Work Order ID 160999

Item ID: 646.3010 Accept ***N900040100*** Setup Start ***NS1***
 Revision ID: Stop ***NS2***
 Item Name: LH Half
 Start Date: 5/9/2017 Start Qty: 10.00 ***10*** Cust Item ID:
 Required Date: 5/31/2017 Req'd Qty: 10.00 ***10*** Customer:
 Reference: (P.A.)SCHEDULED/S

ENGINEERING CHANGE NOTICE NO. 02195		SHEET 1 OF 4	
DWG NO. 646.3000	REV: N/C	PREPARED BY S. HUFF	DATE: 01/05/09
EFFECT ON DWG ☐ INC. ☒ UNINC.			
DWG TITLE: LOWER CUTTER ASSY			
APPROVED BY: ENGR <i>[Signature]</i>	MFG <i>[Signature]</i>	QC <i>[Signature]</i>	EFF: NEXT ORDER
REASON: REMOVED RIVETS IN FAVOR OF ADDITIONAL SCREWS			
TRANSACTION CODES (TC) A-ADD C-CREATE R-REVISE D-DELETE

SHEET 1, ZONE D5, IS:

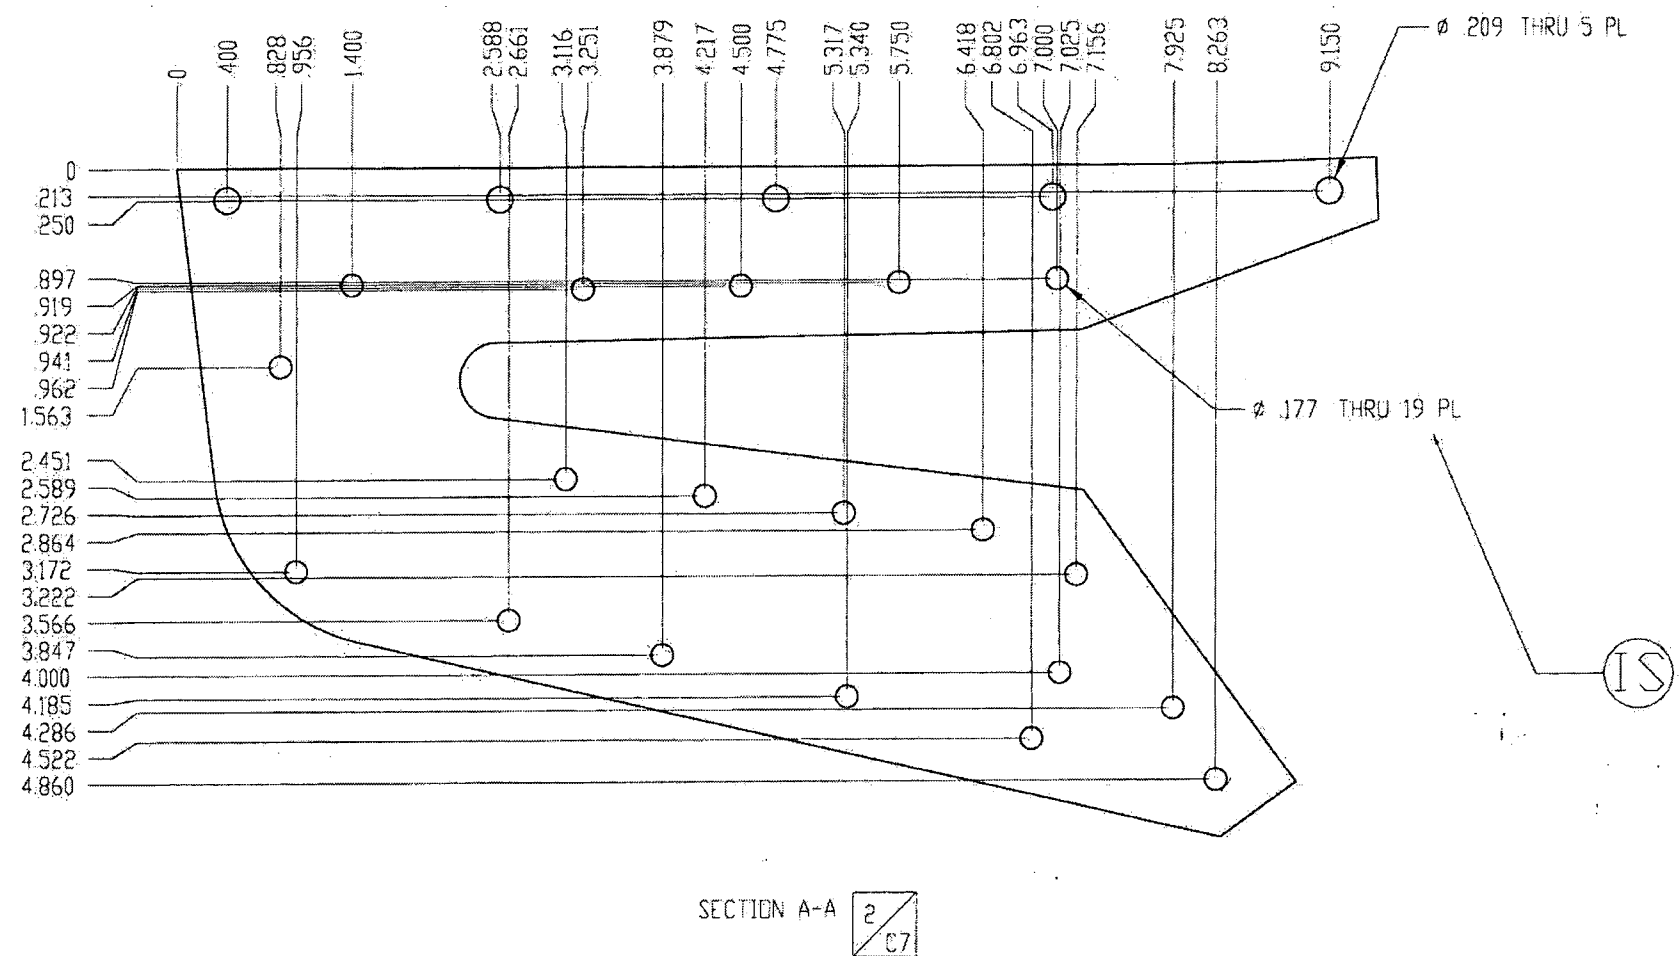
10	R	601.1541	19	LOCKNUT	MS21042L08
9	R	601.2764	38	WASHER	NAS1149FN832P
8	R	601.2765	19	SCREW	MS27039-0819
7	D	601.2766	2	RIVET	MS20470AD5-18
			3001		
F/N	TC	PART NUMBER	QTY	DESCRIPTION	MATERIAL/SPECIFICATION
DOCUMENTS EFFECTED:				☐ MDL ☒ INSTALL INSTRUC ☒ ICA ☐ FMS ☒ BOM	CHANGE CATEGORY ☐ MAJOR ☒ MINOR
				DER REVIEW REQUIRED ☐ YES ☒ NO
